UNITED STATES PATENT AND TRADEMARK OFFICE

APPLICATION NO.	FILING DATE	FIRST NAMED INVENTOR	ATTORNEY DOCKET NO.	CONFIRMATION NO.
10/812,449	03/29/2004	Pauline Maria Foster-Hamilton	0707-00342 - G00342/US	3169

Office Action Summary

DETAILED ACTION

a first stabilizing member (see Figure 1 below) joining the plurality of articulating convolutes and the grease catching member;

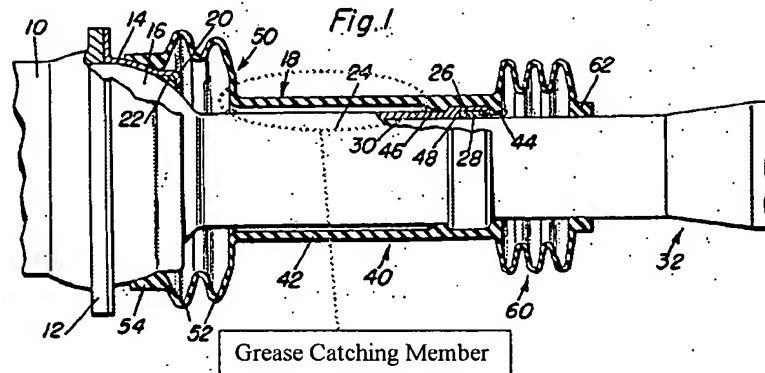
In regards to claim 1, Davis discloses an improved boot for use in sealing a constant velocity joint and ball spline joint assembly, the boot (40) comprising:

a plurality of articulating convolutes (50);

a grease catching member (46);

a plurality of plunging convolutes (60); and

a second stabilizing member (44, 48) joining the plurality of plunging convolutes and the grease catching member.
